Project Name: Ginko Storage

Description: Final site plan approval

RE: **Ginko Self Storage -Final Site Plan/Final Engineering Plan Review-4th Review**
~~Stormwater Maintenance Agreement Review-1st Review~~

Revised Final Site Plan Review for Special Land Use for White Lake Charter Township, Michigan

LB 15 - LB 3 PROFILE

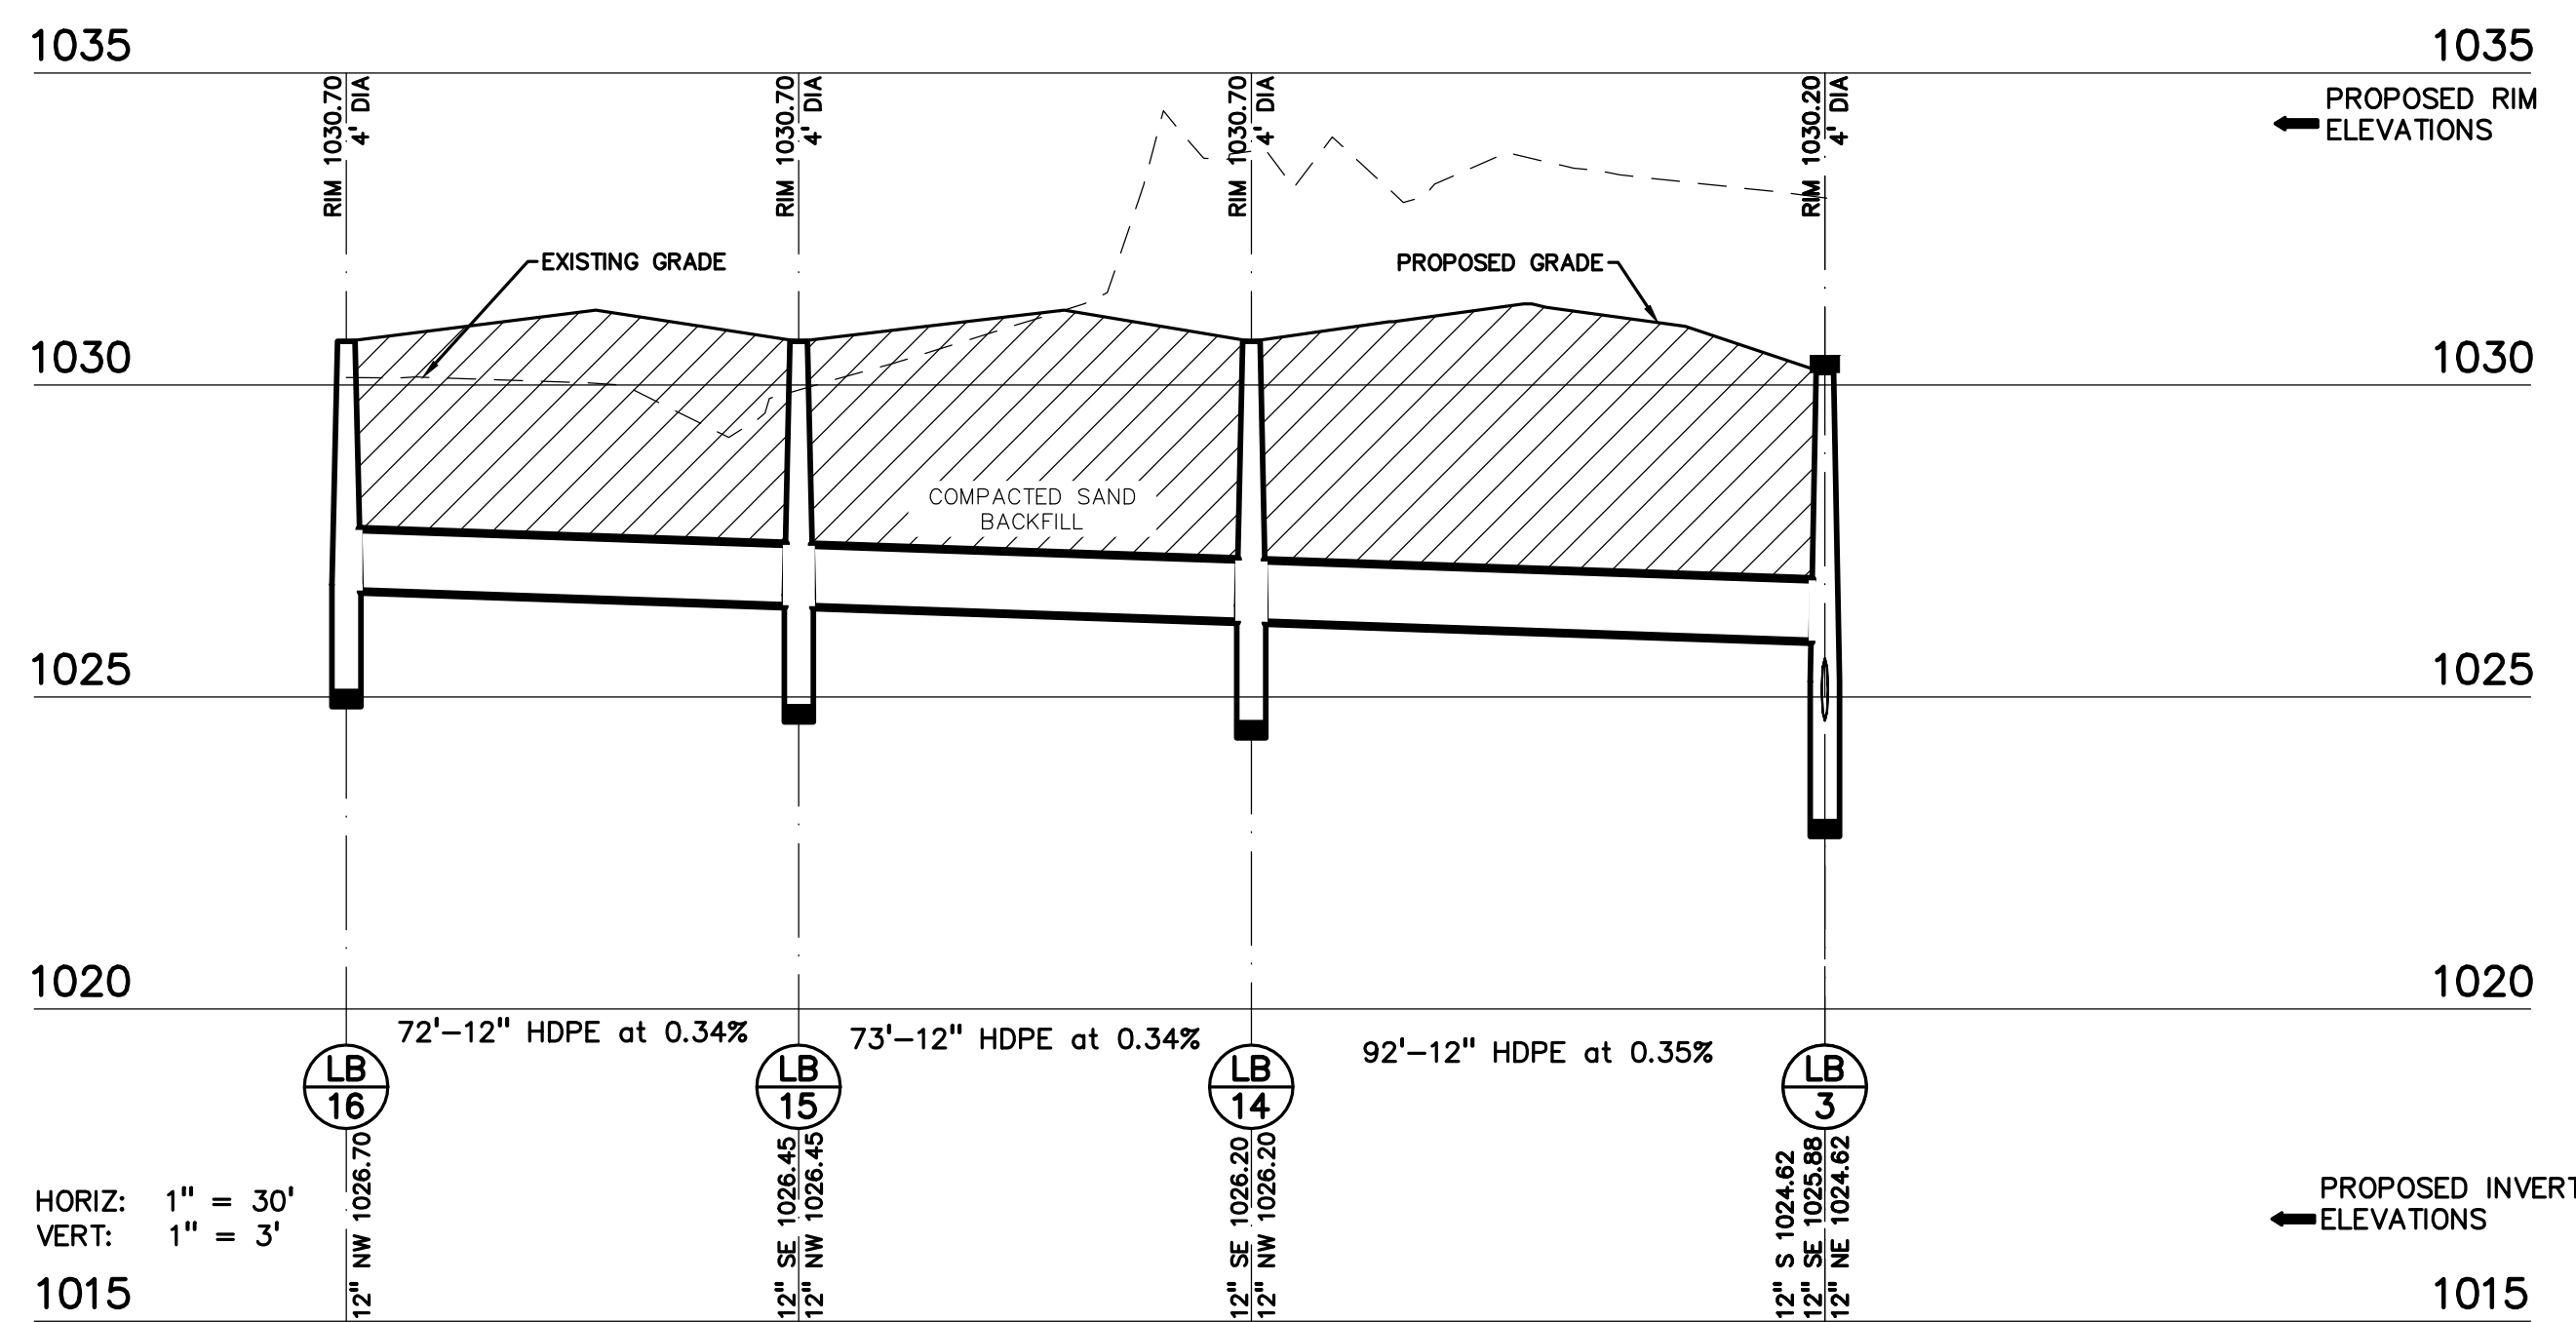
3. Sheet C-7.0- It appears that profiles were not updated based on revised storm sewer structure rim and invert elevations. We have attached a red lined copy of this sheet.

L-1.0

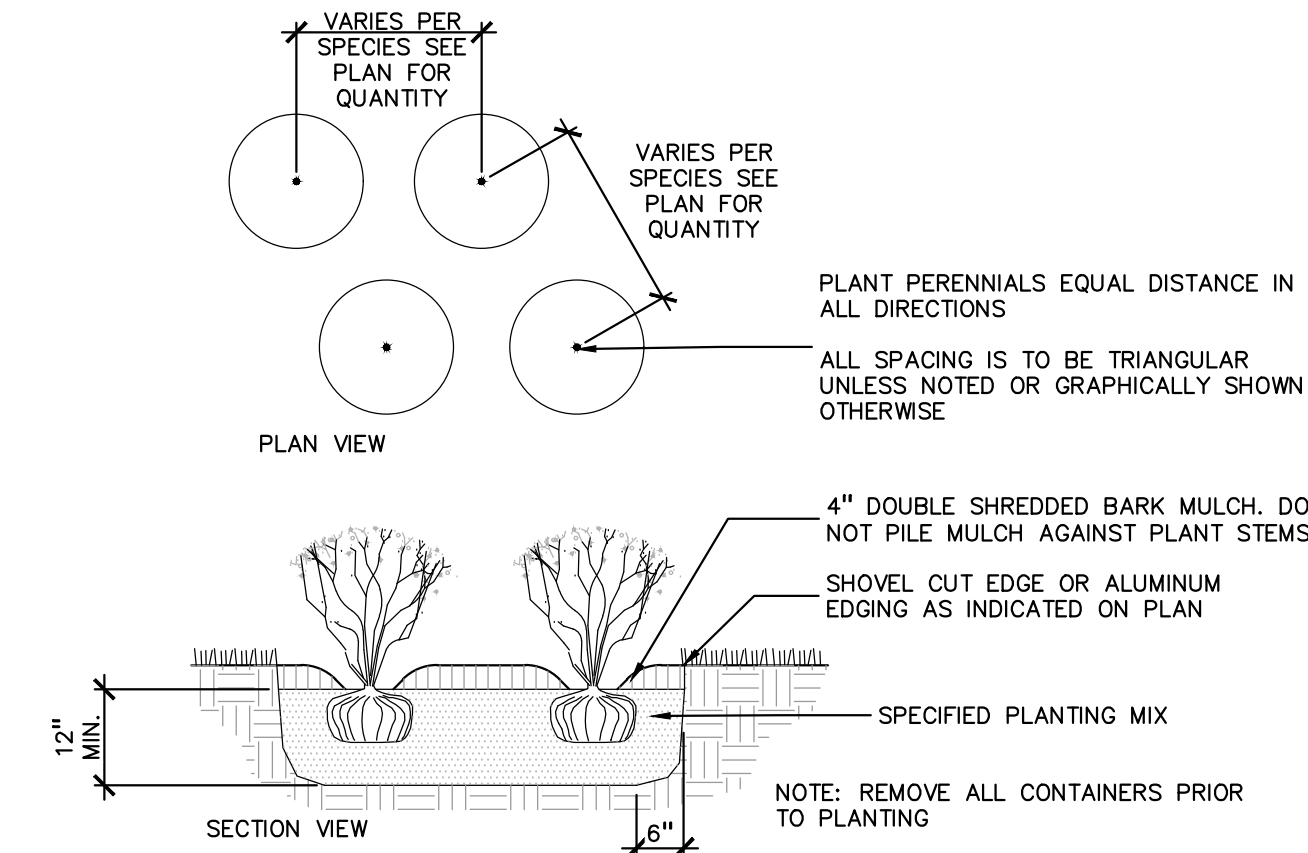
Sheet L-1.0 shows a dense array of new and existing deciduous and evergreen trees as well as numerous shrubs along the western property line. Protective fencing is shown encompassing existing trees during construction. A 19.5 foot wide buffer is shown along White Lake Road and meets the requirements of landscape screening by plant count but not by depth. The buffer should be increased to 20 feet or a variance from the Zoning Board of Appeals will be required.

- 1.) *As noted in the Parking and Loading section of the review, a 19.5 foot wide buffer is shown along White Lake Road and meets the requirements of landscape screening by plant count but not by depth. The buffer should be increased to 20 feet or a variance will be required from the Zoning Board of Appeals.*
- 2.) *The Planning Commission will need to determine if the non-obscuring fencing is acceptable.*
